RENESAS TECHNICAL UPDATE

Product Category	MPU/MCU		Document No.	TN-RL*-A003A/E	Rev.	1.00
Title	Correction for Incorrect Description Notice RL78/G13 Descriptions in the Hardware User's Manual Rev. 2.00 Changed		Information Category	Technical Notification		
Applicable Product	RL78/G13 Group R5F100xxx, R5F101xxx	Lot No.	Reference Document	RL78/G13 User's Manual: Hardware Rev. 2.00 R01UH0146EJ0200 (February 2012)		
		All lot

This document describes misstatements found in the RL78/G13 User's Manual: Hardware Rev. 2.00 (R01UH0146EJ0200).

Figure 20-2. Timing of Generation of Internal Reset Signal by Power-on-reset Circuit and Voltage Detector

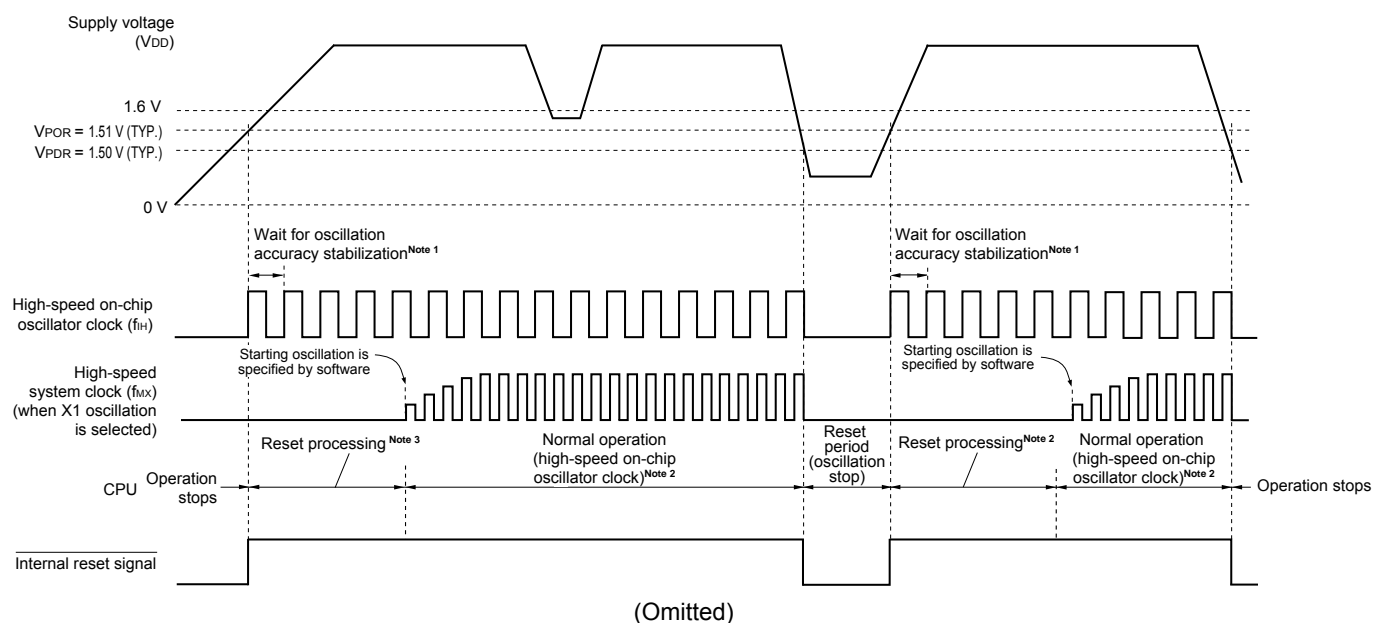
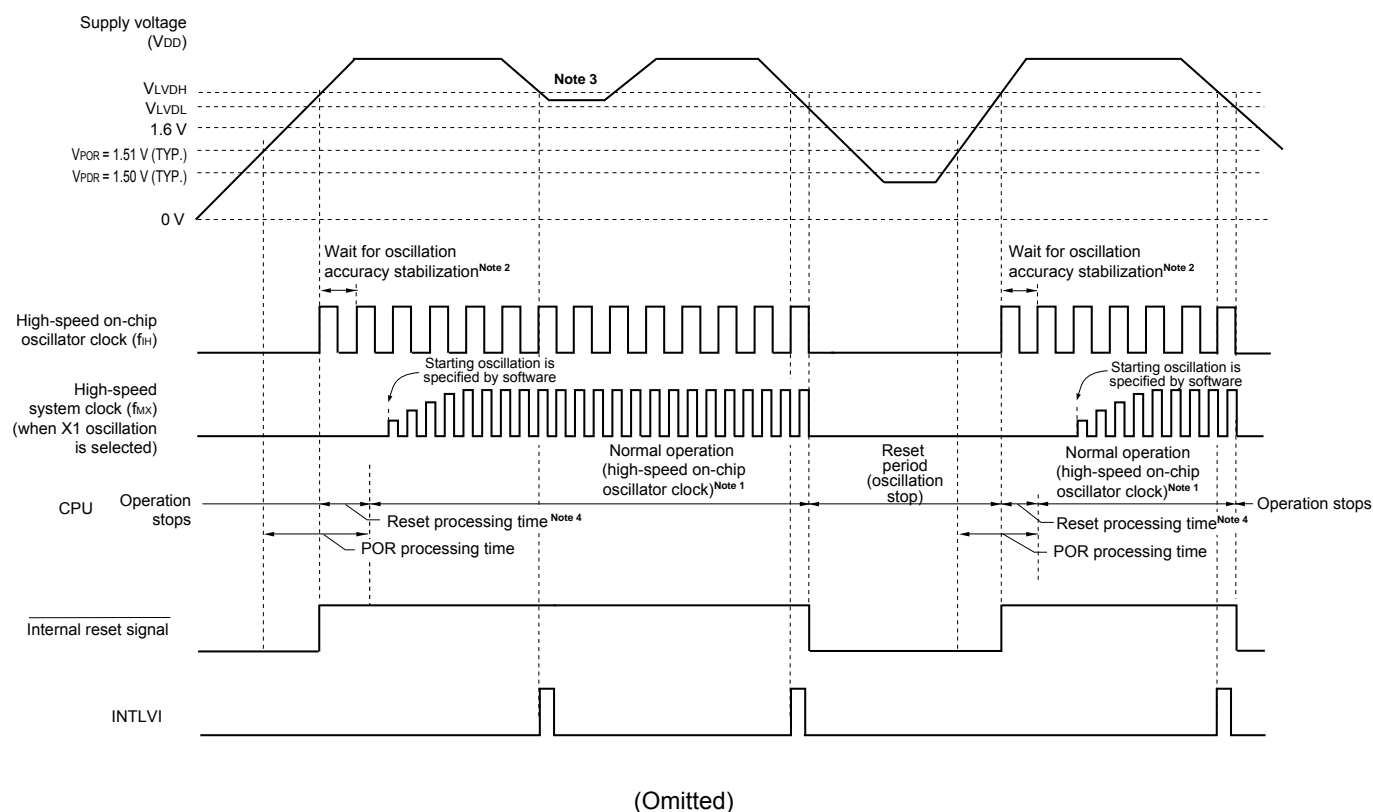
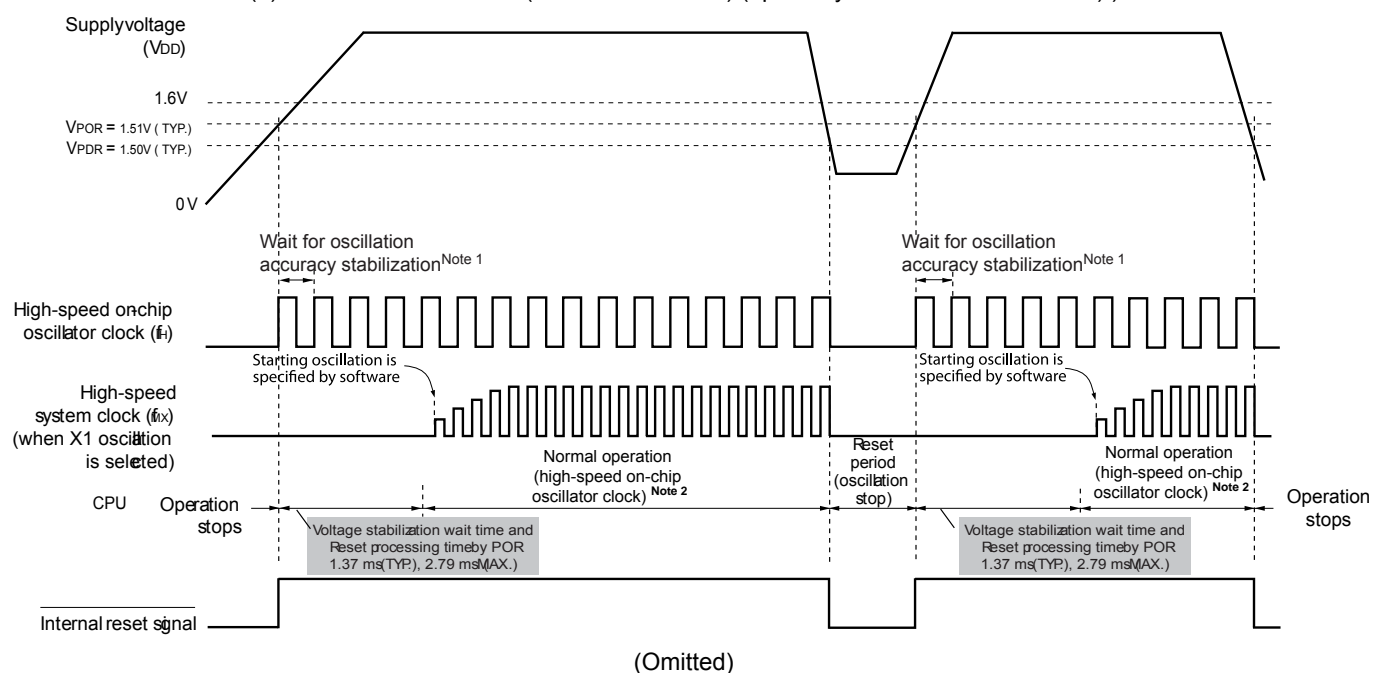
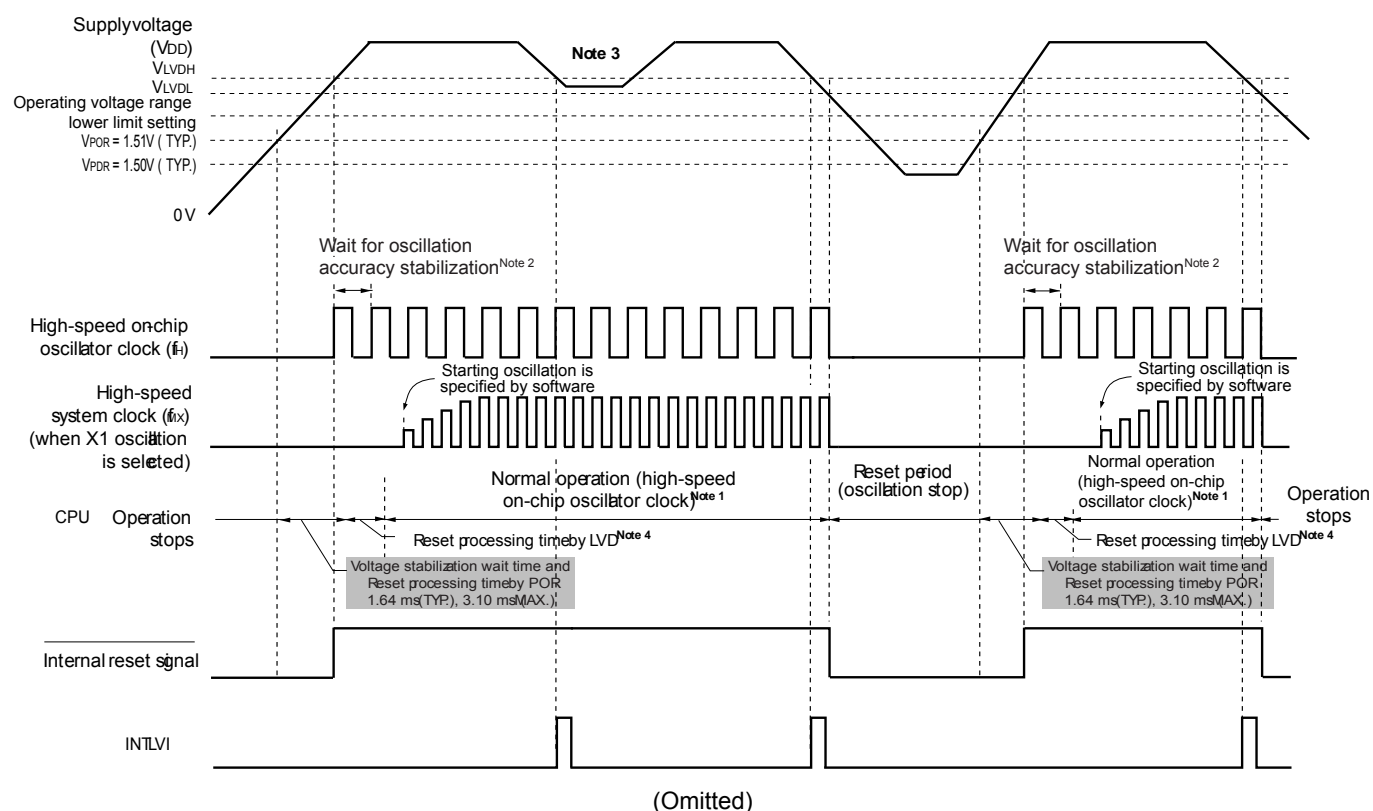
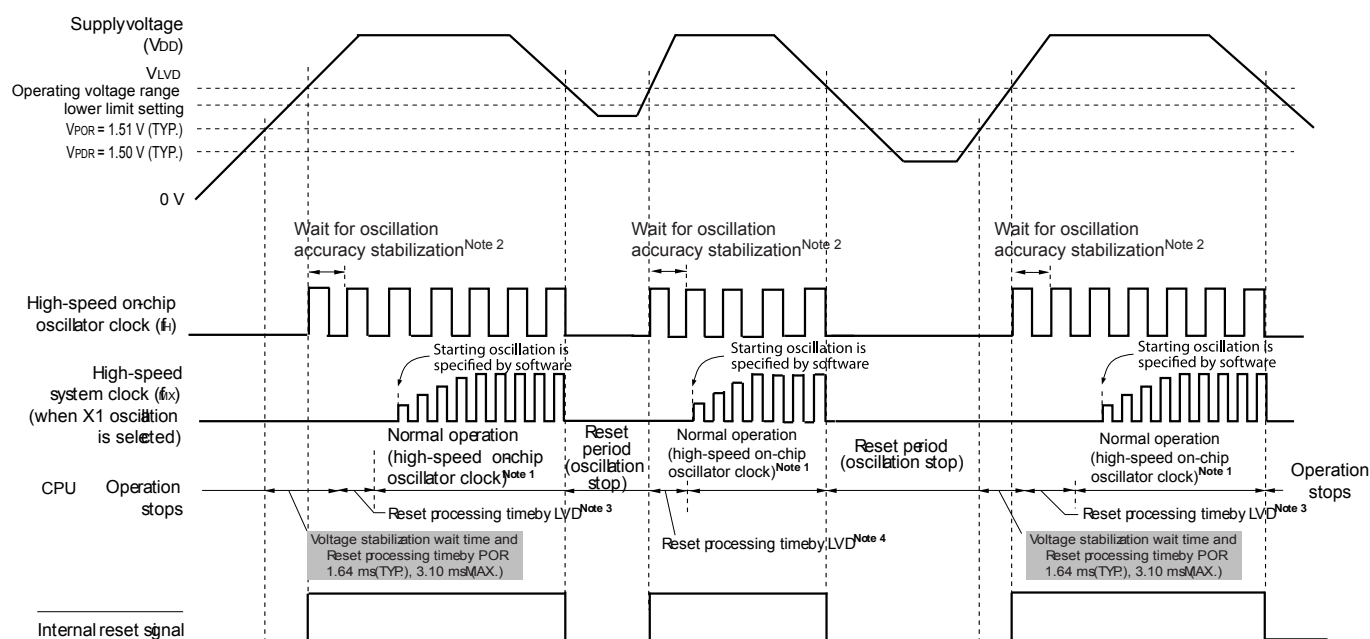
4. Incorrect descriptions of the power-on reset circuit on Figure 20-2 revised (pages 875, 876)

Notes 3. Reset processing time: 265 to 407 μ s

Notes 4. Reset processing time: 497 to 720 μ s

Note 4. The time until normal operation is started require the following “the reset processing time by LVD” required after the voltage has reached LVD detection level (VLVDH), in addition to “the reset processing time by POR” and “the voltage stabilization wait time” required after the voltage has reached VPOR (1.51 V (TYP.)).

Reset processing time by LVD: 0 ms to 0.0701 ms (MAX.)

Note 3. The time until normal operation is started require the following “the reset processing time by LVD” required after the voltage has reached LVD detection level (V_{LVD}), in addition to “the reset processing time by POR” and “the voltage stabilization wait time” required after the voltage has reached V_{POR} (1.51 V (TYP.)).

Reset processing time by LVD: 0 ms to 0.0701 ms (MAX.)

- When supply voltage falls and returns after only an internal reset occurs by the voltage detection circuit (LVD), the following “the reset processing time by LVD” is required after the voltage has reached LVD detection level (V_{LVD}).

Reset processing time by LVD: 0.0511 ms (TYP.), 0.0701 ms (MAX.)
